Nº 1006 MAIN BOILER

FORWARD BOILER

H.M.S. PRIMOLA

Report No. 68366

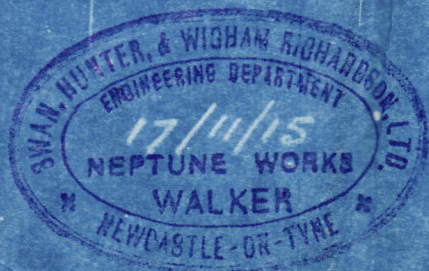
CRACK $2\frac{1}{4}$ LONG

5/8 STUD SCREWED IN
AND FLUSH RIVETED

POSITION OF CRACK
ABOUT 7" TO STARB^d
SIDE FROM CENTRE

See Amended print
